Municipal Planning & Design Review Commission
Regular Meeting Agenda
Thursday, January 20, 2022, 5:30 PM
City Hall, Lakeland, Tennessee 38002

Subject: Action on Approval of Sign Permit Application Wall Sign, Window Signs, Identification Signs – Banfield Pet Hospital at 8950 U.S. Highway 64.

Subject: Action on approval of an Amendment to an Outline Plan - Lakeland Commons Planned Development.

Subject: Review and feedback on a Sketch Plan Application – Taylor Farms PD

Removed other options
Removed red
Removed proposed elevations for Rear, Left & Right Sides

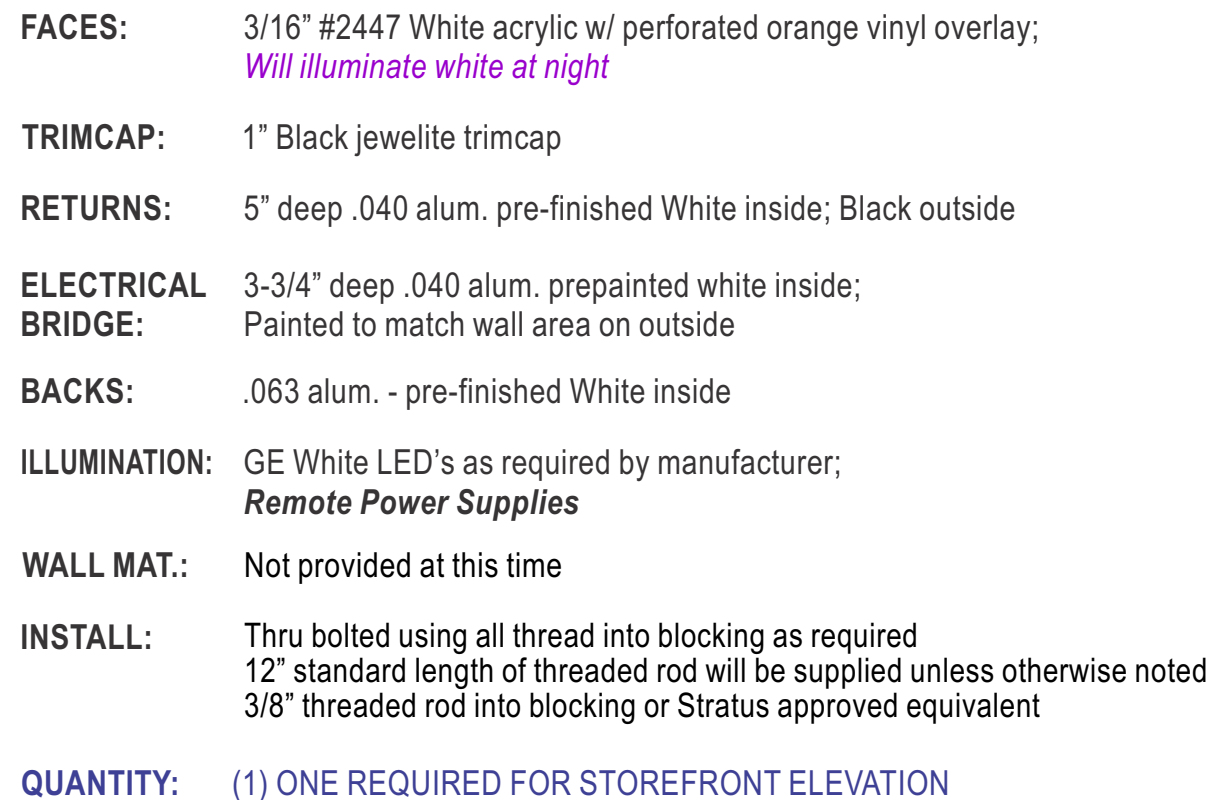
The sign application has been reviewed by staff with comments. The applicant initially proposes a wall sign for each side of the building. This goes against our sign ordinance which only allows for one wall sign per frontage. The applicant has also been asked to articulate the placement of the parking lots signs on their site plan. Lastly, the applicant was instructed to show on the elevations that the window sign allotment of 25% would not be breached. The applicant has

submitted revisions to their application, and they meet sign ordinance requirements. As a result, staff recommends approval of the sign application.

REAR ELEVATION

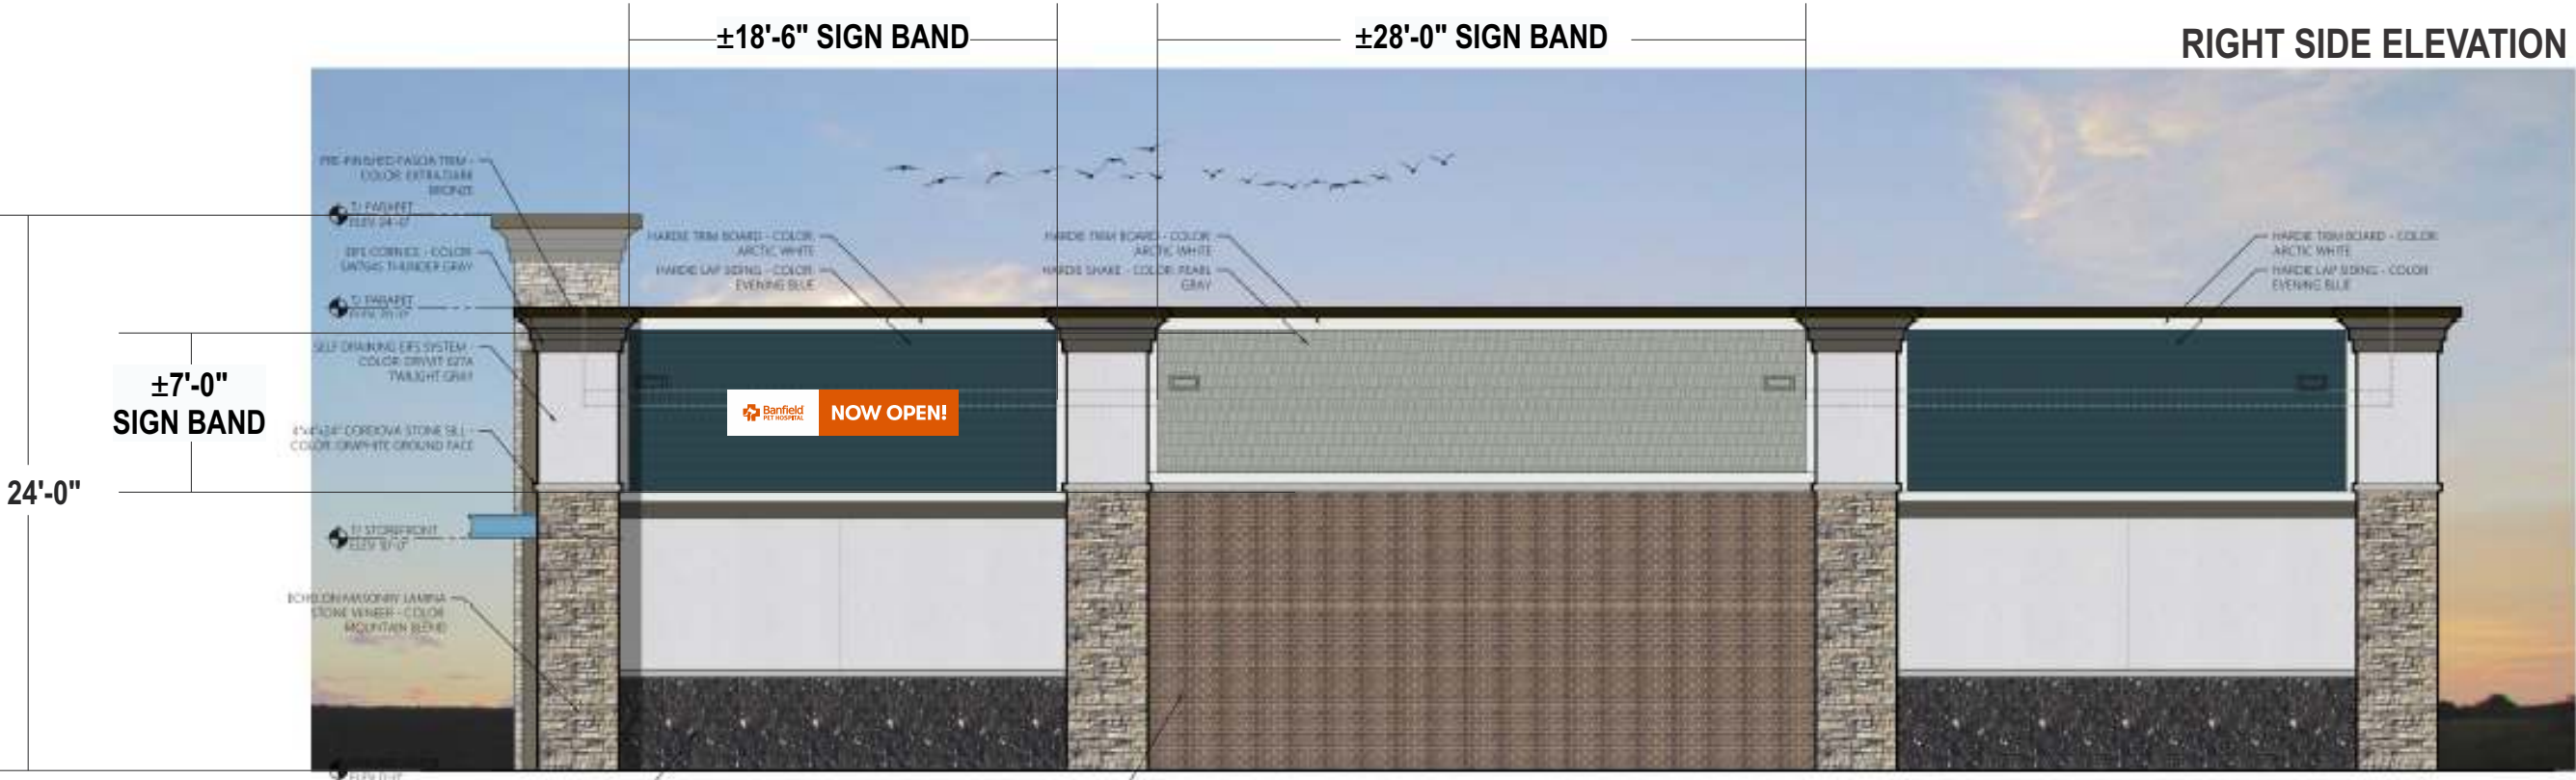
Updated approved lettersets
Removed red
Removed Letterset from rear elevation

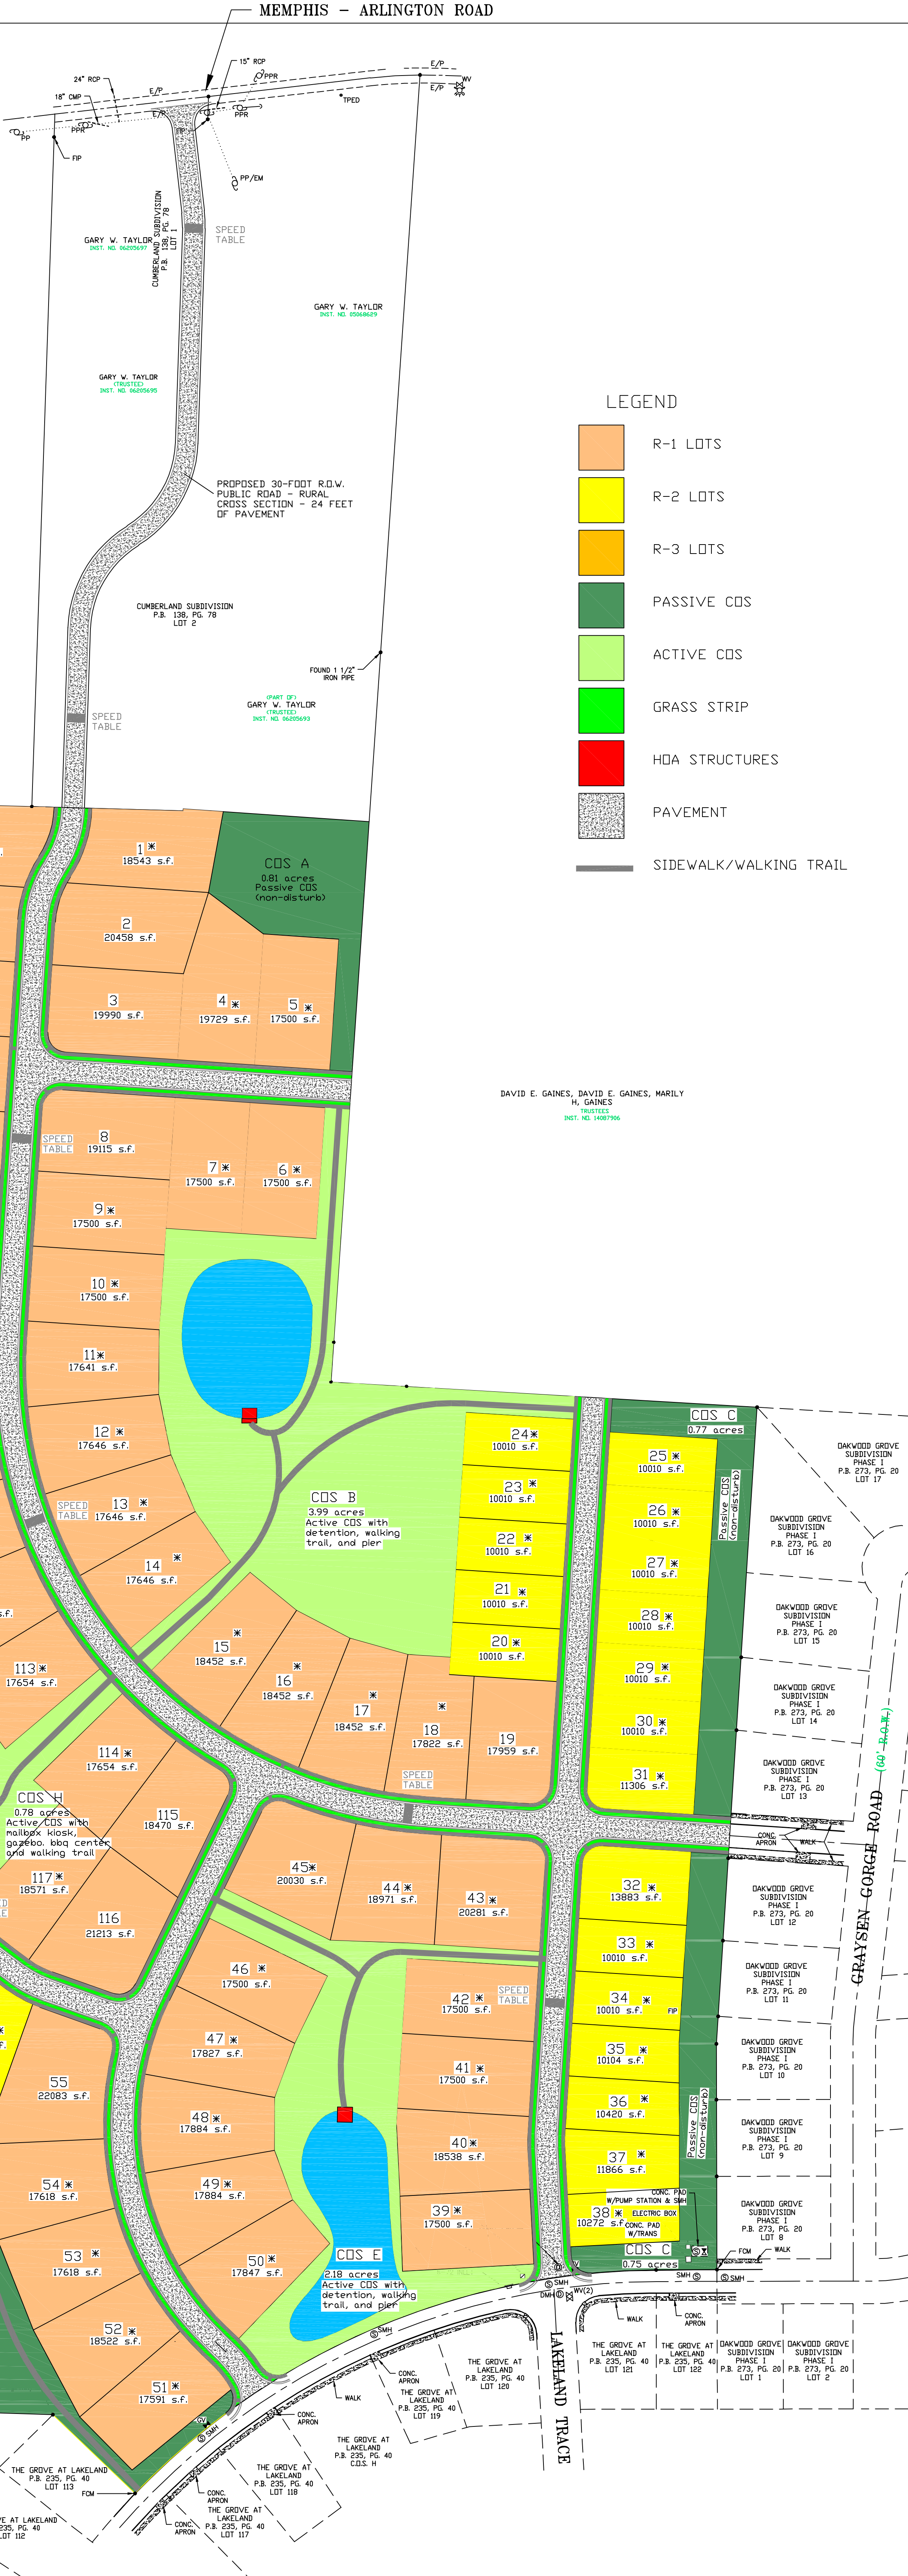
- Reduced number of lots to preserve more of the tree canopy on site i.e. conservation preservation
- Increased pavement width and street cross section of main drive to match the road section of Lakeland Trace south of Maple Walk Drive.
- Increased buffer along west property line, north of Ramblewood drive.
- Added the 2 estate lots of 4+ acres that are south of Memphis Arlington Rd
- Decreased density from 2.17 du/acre; last plan was 1.87 du/acre
- Reconfigured open space that was to the rear of rear loaded lots to the front side
- Added Access to the residential developments to the east and west as well as a stub street to the undeveloped large acreage to the NE of the property.
- Provide offsite connections to stub streets.

The Open Space is simply open space and does not add value through trails, benches, or other amenities as typically of other PDs.

- The applicant has added a 50-foot buffer to the west side of the development.
- The applicant has added the sidewalk network to the plans.
- The applicant has also added the connection to Memphis-Arlington Road.
 - It is not clear what the intended zoning district the land on either side of the connection would be. If let AG it would have a 5 acre minimum.
 - Also the remainder of the subdivision shows the side walk and planting strip in the ROW while the connector has a 30' ROW.
